# Broken Hill Battery Energy Storage System Project

Submissions Report

30-Jul-2021

**Figure 1 Upstream catchment**

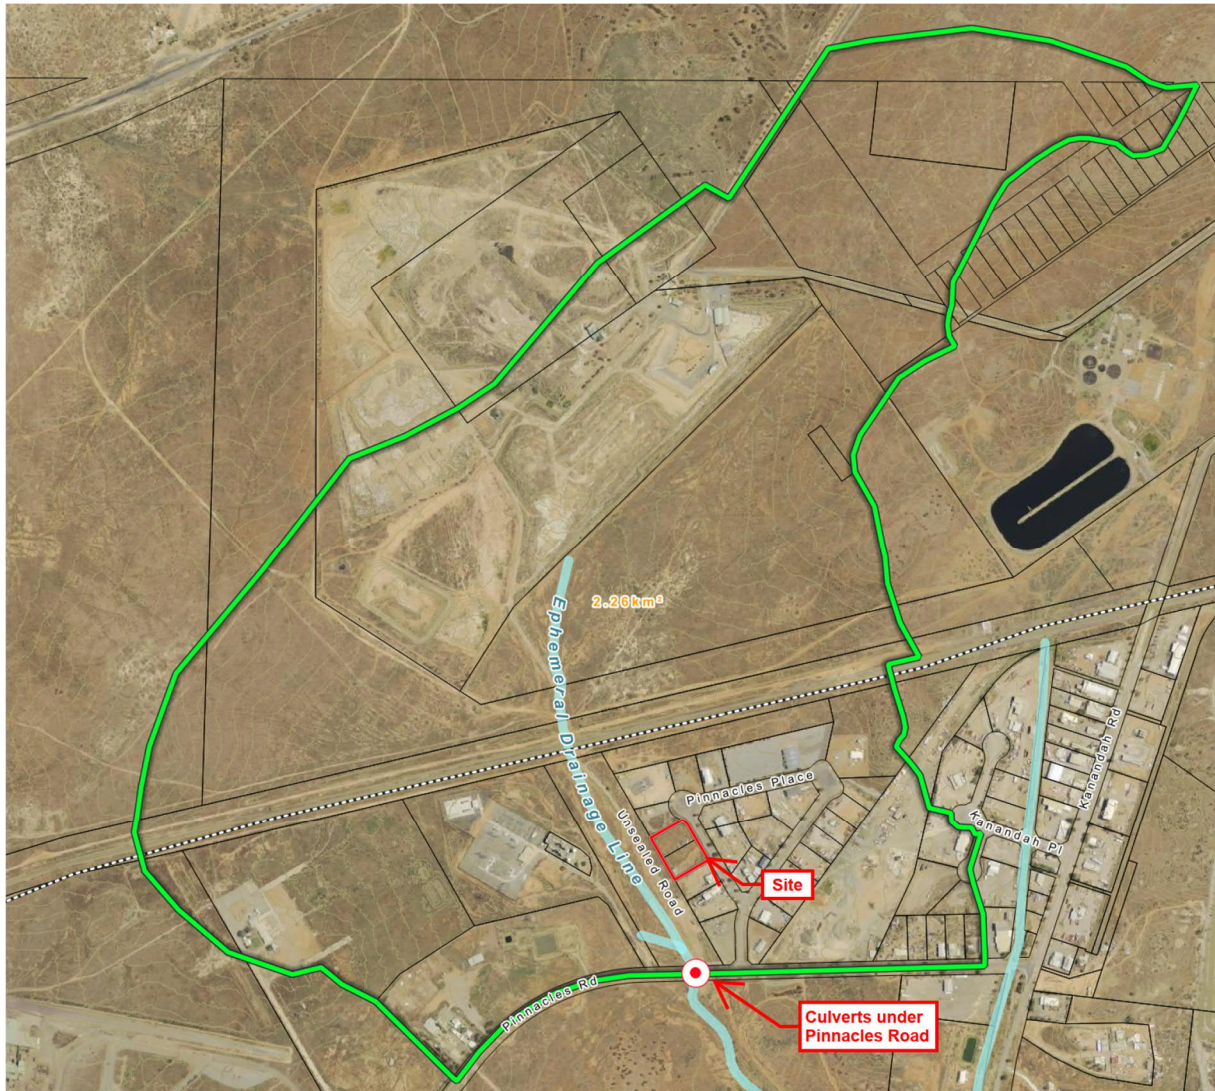
There is large upstream catchment, in the order of 2.26 km<sup>2</sup>, that contributes to flow along the ephemeral drainage line as moves past the Site. This catchment is shown in Figure 1.

The calculations indicated that the large upstream catchment would generate a peak flow rate in the order of 15.2 m<sup>3</sup>/s in a 1% AEP storm event. These calculations are provided as an attachment.

**Figure 4 Modelled flood extents**

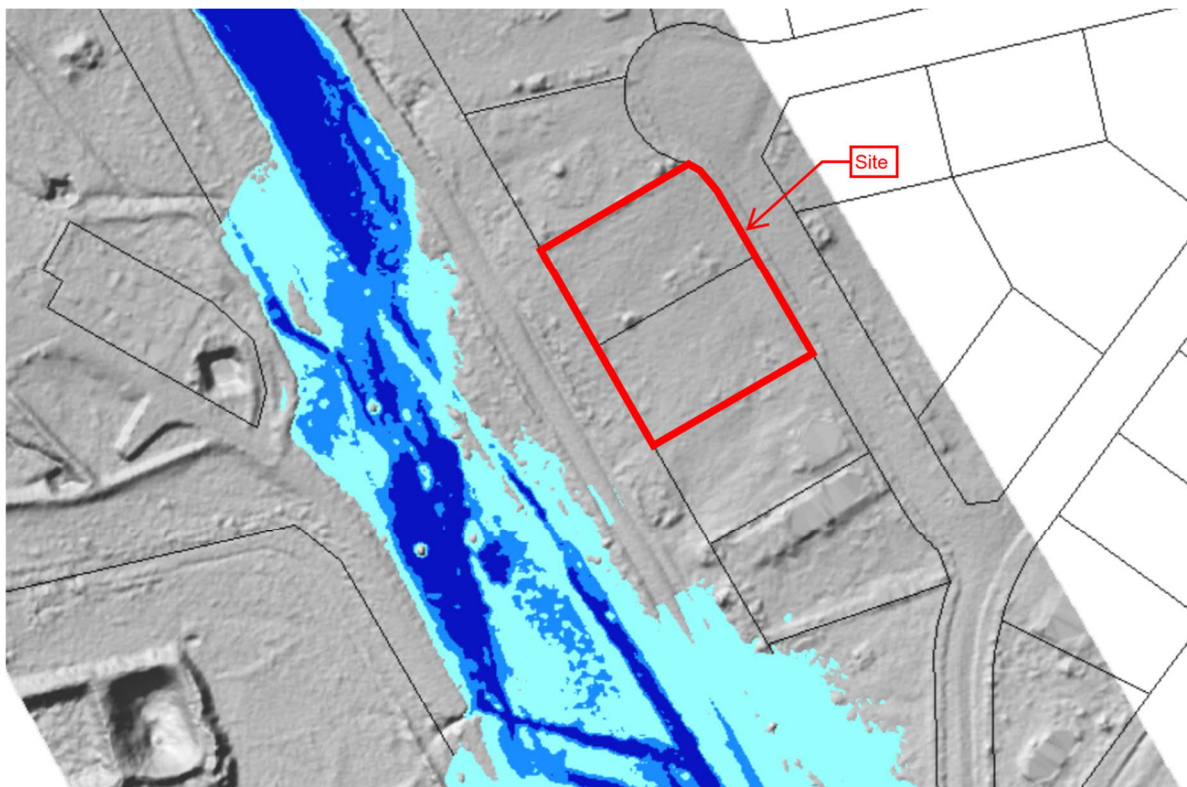
The modelled results for the 1% AEP event, including the flood extents, velocities and water surface profile, are attached. The flood extents, relative to the Site, are also shown in Figure 4.

It can be seen that the Site is not impacted by flooding along the ephemeral drainage line in all events up to and including the 1% AEP event. Based on existing surface levels along the western boundary of the Site, it can achieve at least 0.4 m freeboard to the 1% AEP flood levels. Important infrastructure within the Site would be set at even higher levels, which would provide an adequate level of flood protection to important infrastructure located within the Site.
